Office Action Summary

10/733,256

CROSNIER ET AL.

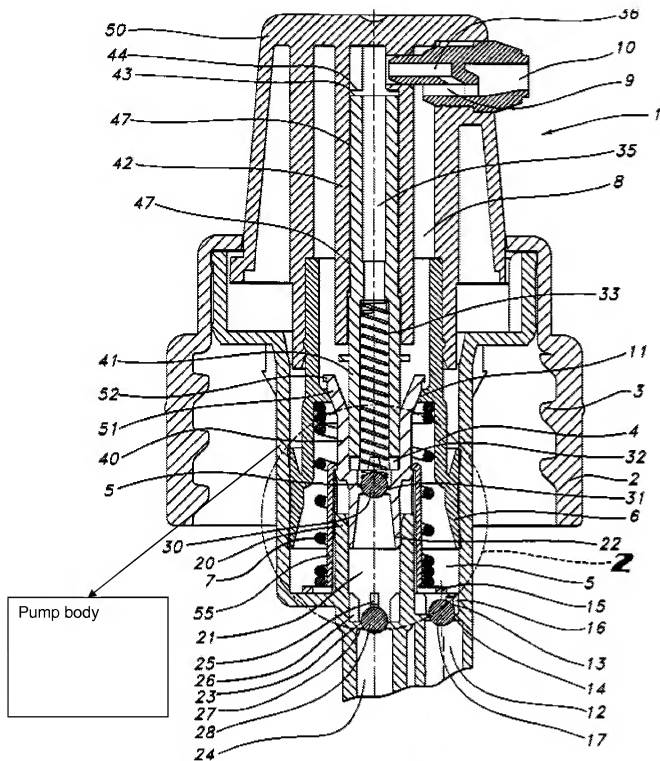
2. Claims 31,33 are rejected under 35 U.S.C. 102(b) as being anticipated by van der Heijden 6,220,483.

Van der Heijden discloses a pump for mounting on a receptacle as seen in Figure 1, which comprises a dispenser orifice (10), a pump body (see marked drawing below), the pump body including a spike (40), a moving body (50) being movable relative to the receptacle, including a pushbutton and defining with the pump body a pump chamber (5) of variable volume, the moving body including a skirt (4) defining a passage via which substance present in the chamber is delivered toward the dispensing orifice (col. 4, ll. 37-47), the skirt co-operating with the spike when the pump is at rest to isolate the inside of the skirt from the pump chamber as seen in Figure 1.
